### 33.4.8.2 Alternative A Midspan PSE signal path requirements

#### 33.4.8.2.1 Alternative A Midspan PSE Compliance test setup

Figure 33-24-1. Measurement Setup For Alternative A Midspan PSE Transfer Function

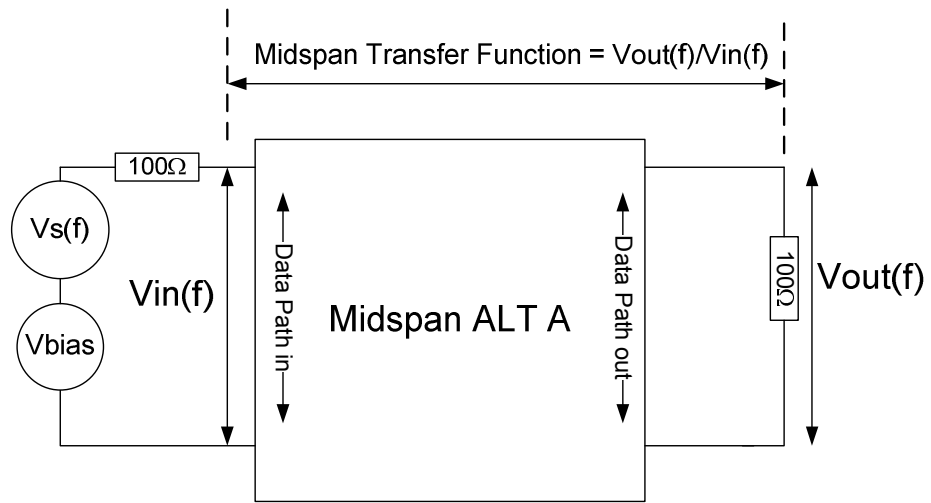
Compliance testing shall be performed by applying test signal to the Midspan PSE signal input ~~with~~ through a source impedance of  $100 \Omega \pm 1\%$ . The Midspan signal input and output shall ~~will~~ be connected ~~to~~ with no more than a 0.5 m length  ~~$\pm 10\%$~~  CAT5 cable, terminated with  $100 \Omega \pm 1\%$ .

The transfer function ~~will~~ shall be measured from the output termination to the signal input. ~~test signal source~~. See figure 33-24-1.

- $V_{in}(f)$  is the Sine wave signal to be used to measure the Midspan TF.
- $V_{bias}$  is the DC offset voltage to be superimposed on the Sine wave in order to generate  $I_{bias}$ .
- $V_{out}(f)$  is the Midspan response to  $V_{in}(f)$
